CITY OF PORTLAND BUILDING PERMIT

Job ID: 2012-06-4137-ALTR

has permission to Second Floor Addition for 1 Bedroom & Office Space

41 Montreal Street
Portland, Maine

PLOT PLAN: 41 MONTREAL ST

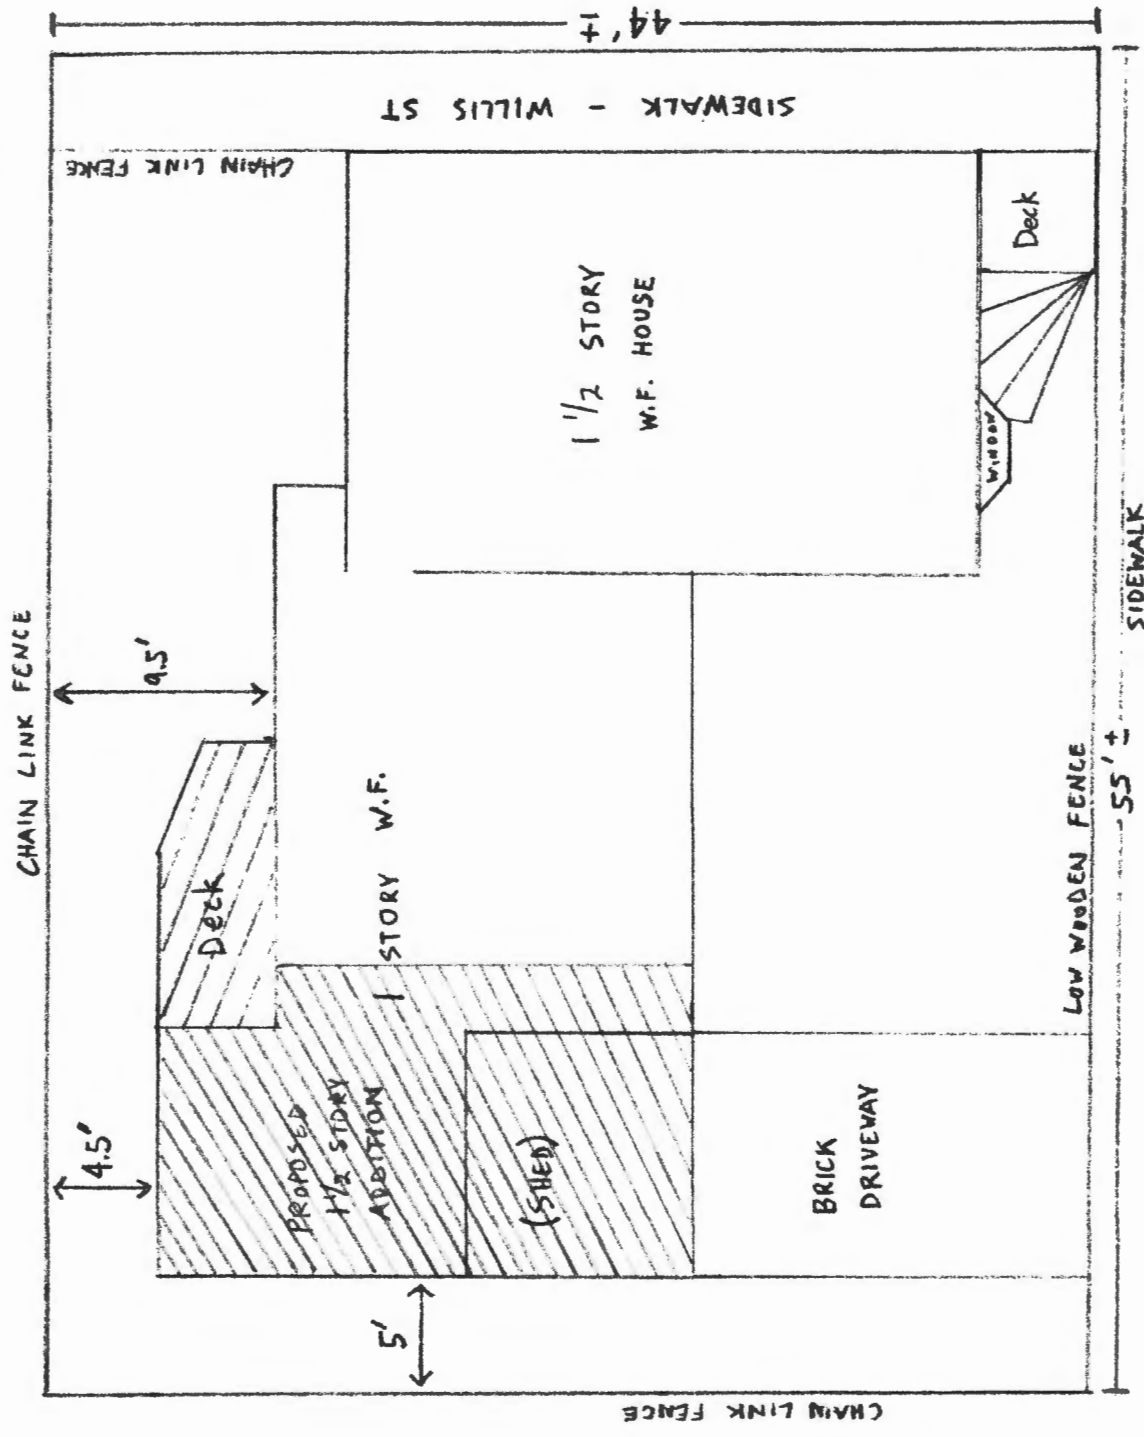
needs piece section 14-4526(6) - 50%

adding - 4800 = 462 increase.

SECTION
A1.4

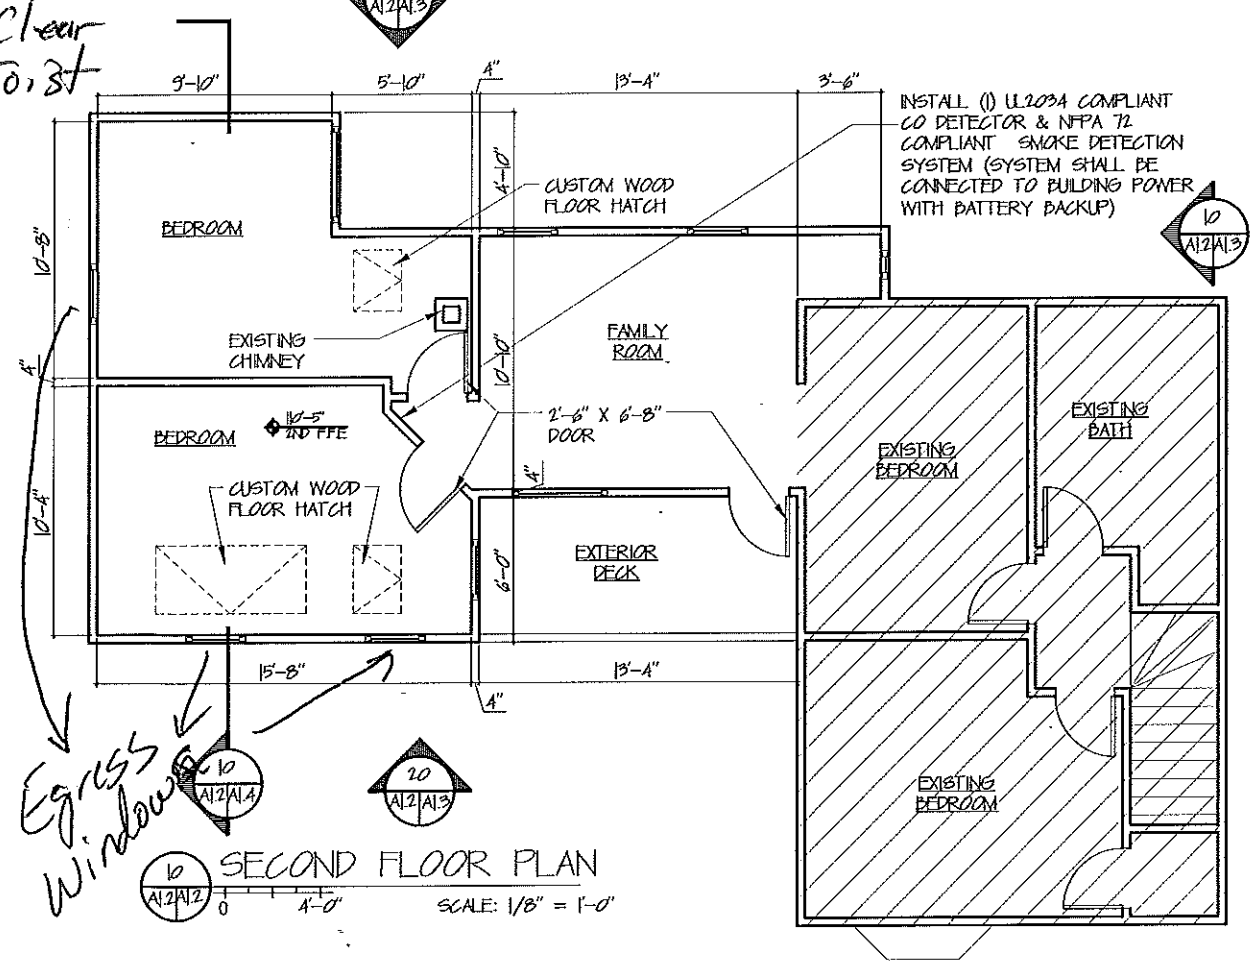
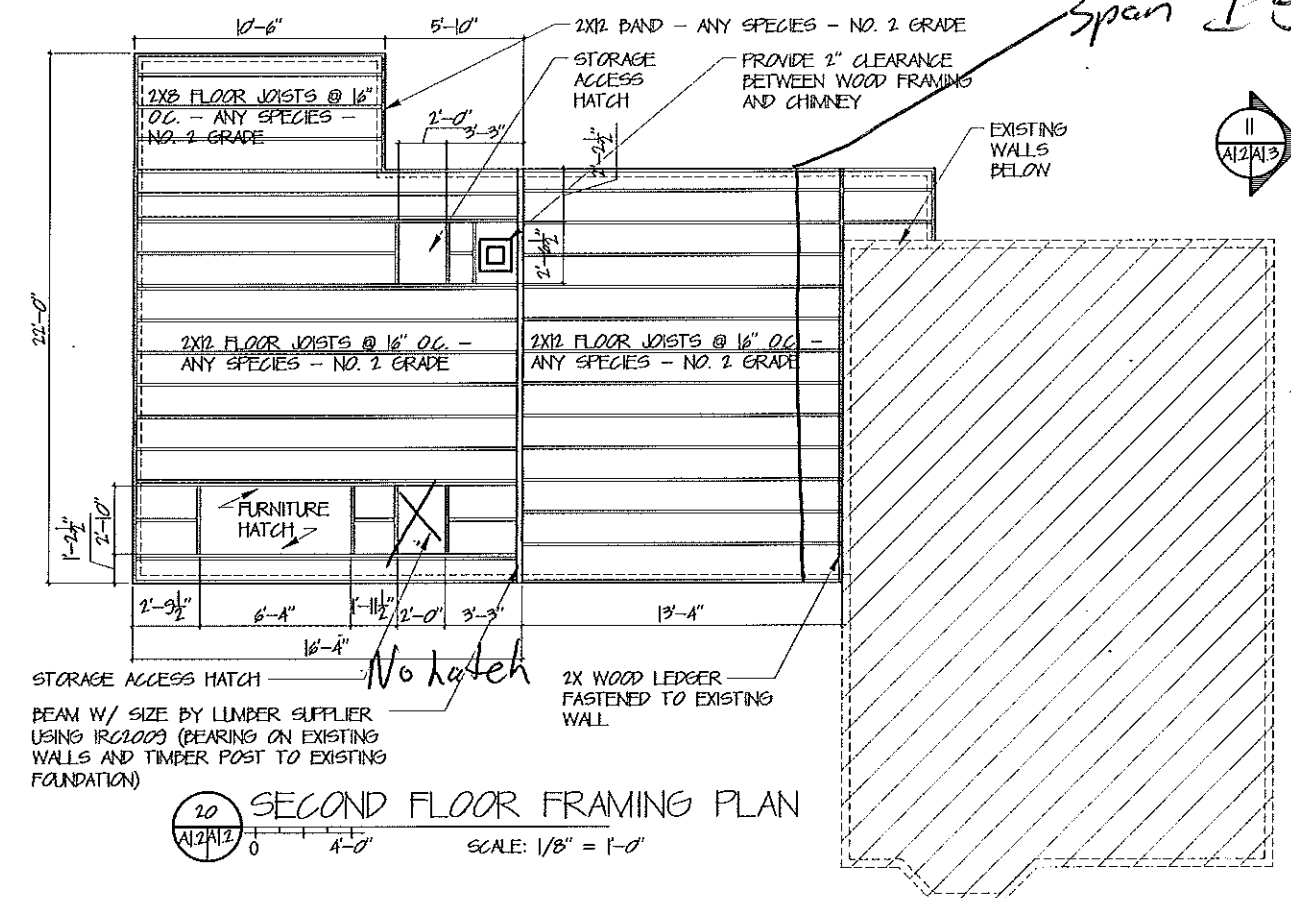
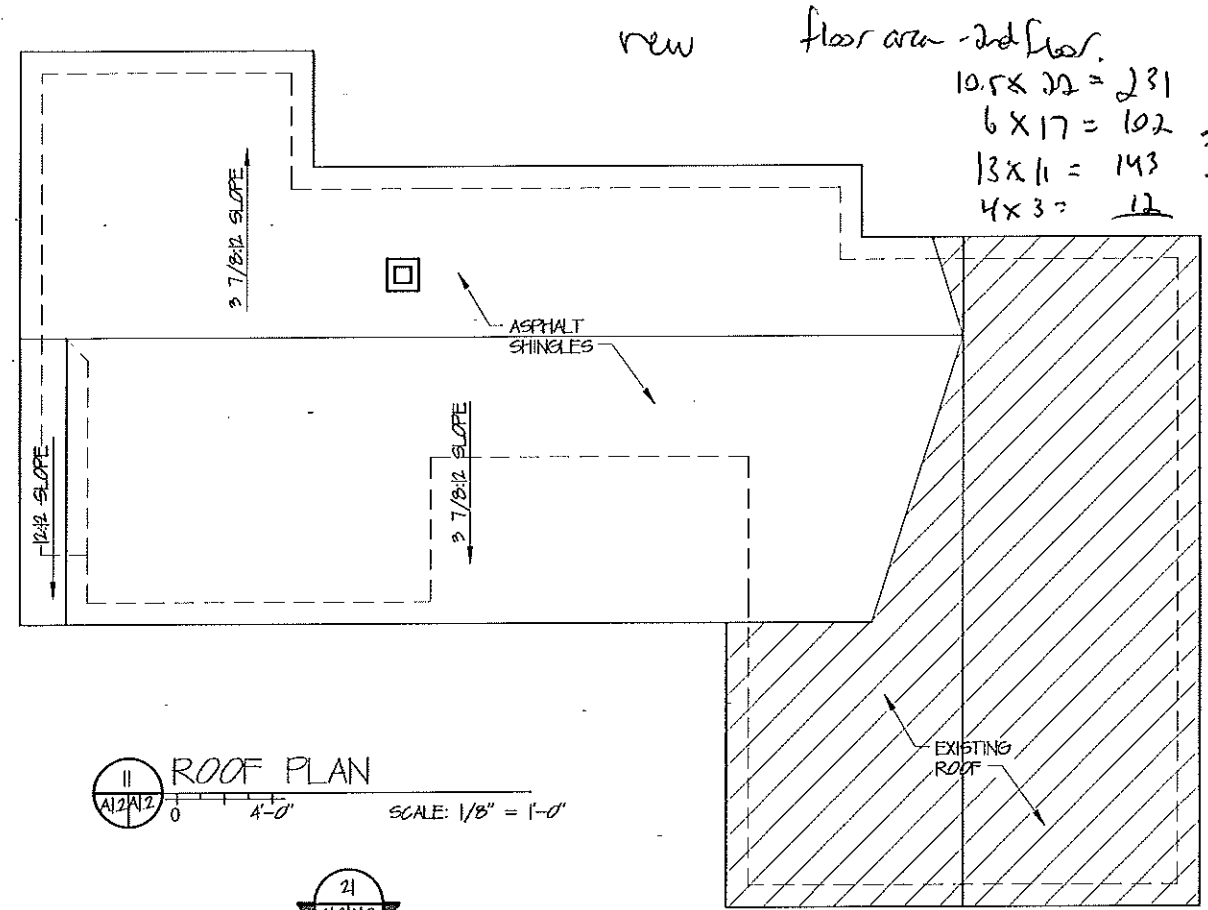
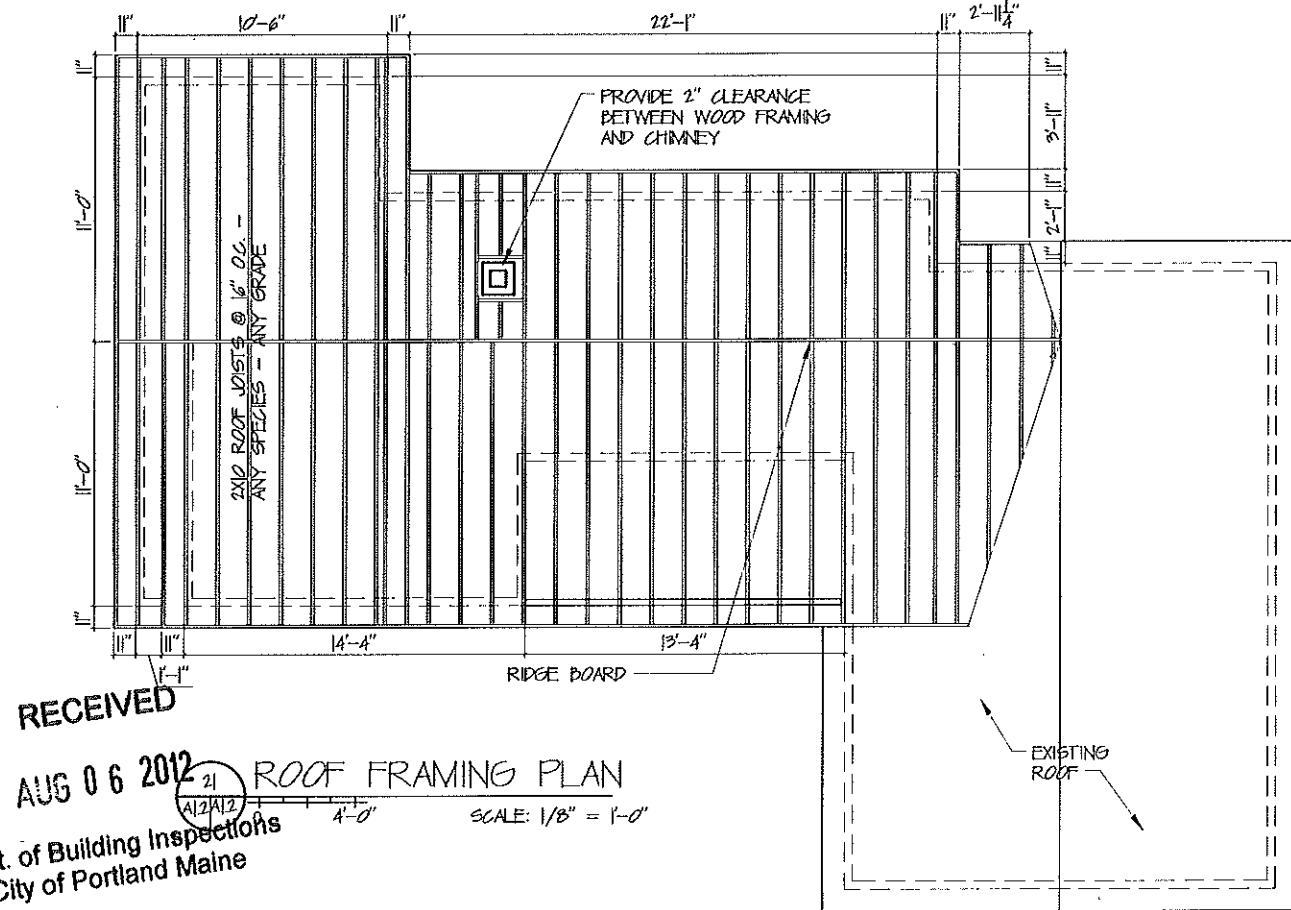
17' over
30" will
add attic
access

2x10
11' span

15'-1" x
0.67 =
10.05 ft

Need
2x12's

2x10's - ok
will have ceiling
joist & top plate

11 EXISTING FIRST FLOOR
SCALE: 1/8" = 1'-0"

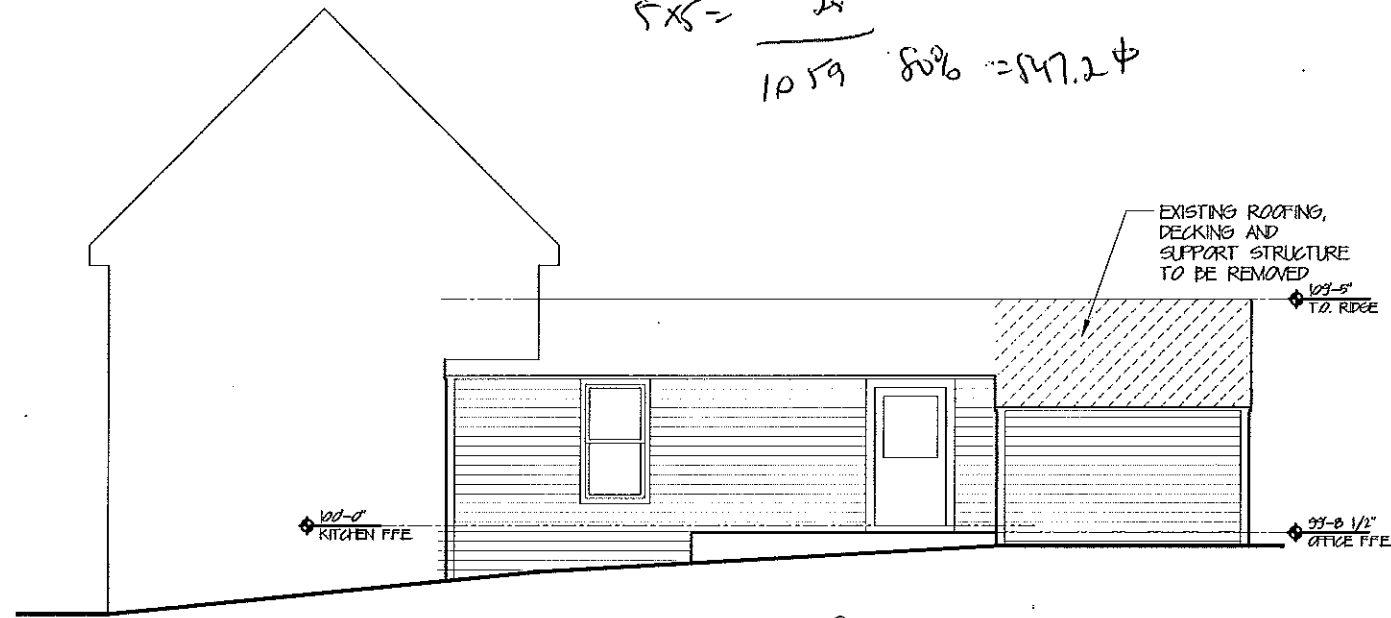
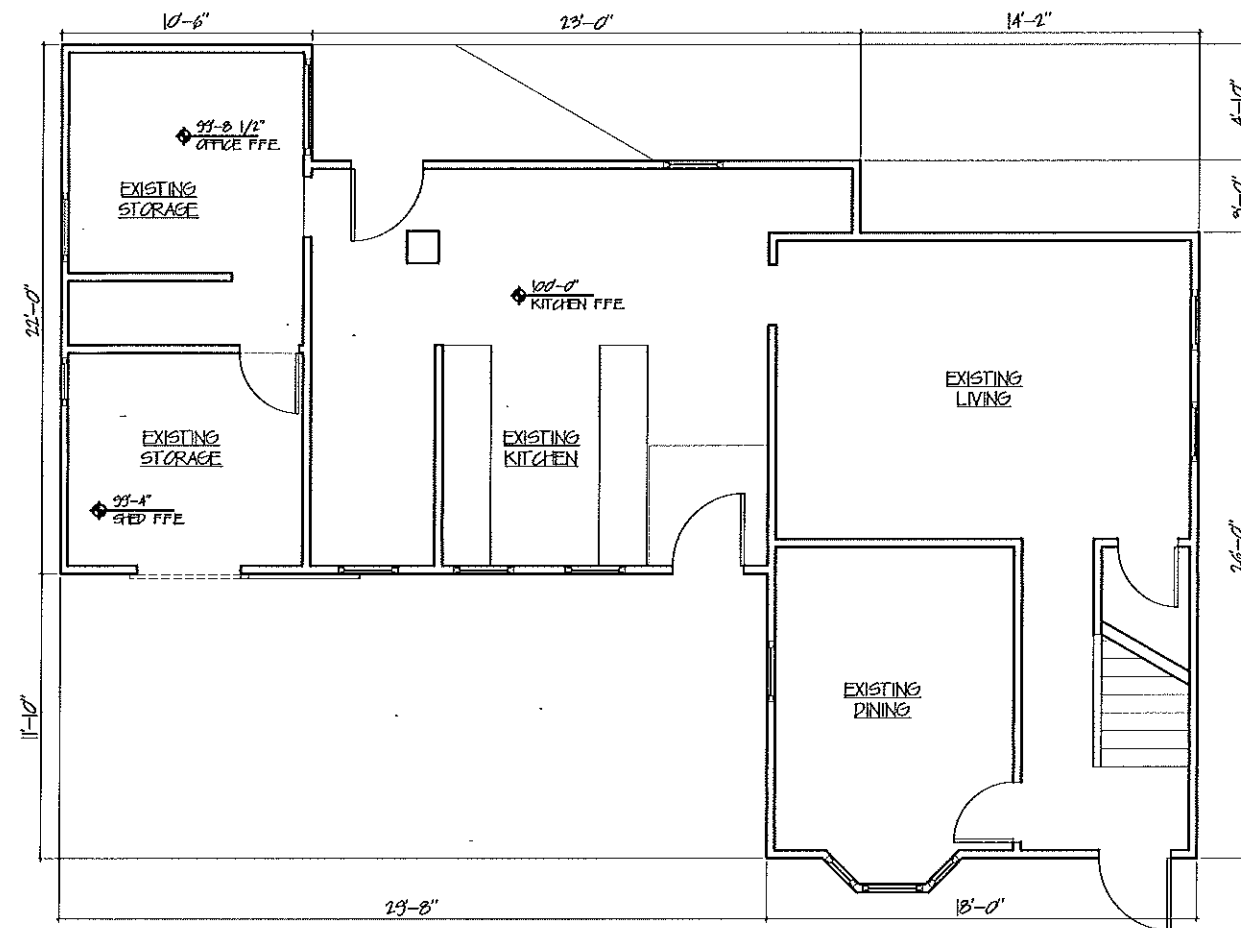
1st floor footprint $10.5 \times 22 = 231$
 $19 \times 17 = 323$
 $19 \times 26 = 468$
 $4 \times 3 = 12$
 $\frac{1034}{1059}$
 $5 \times 5 = 25$
 $80\% = 847.2 \text{ sq ft}$
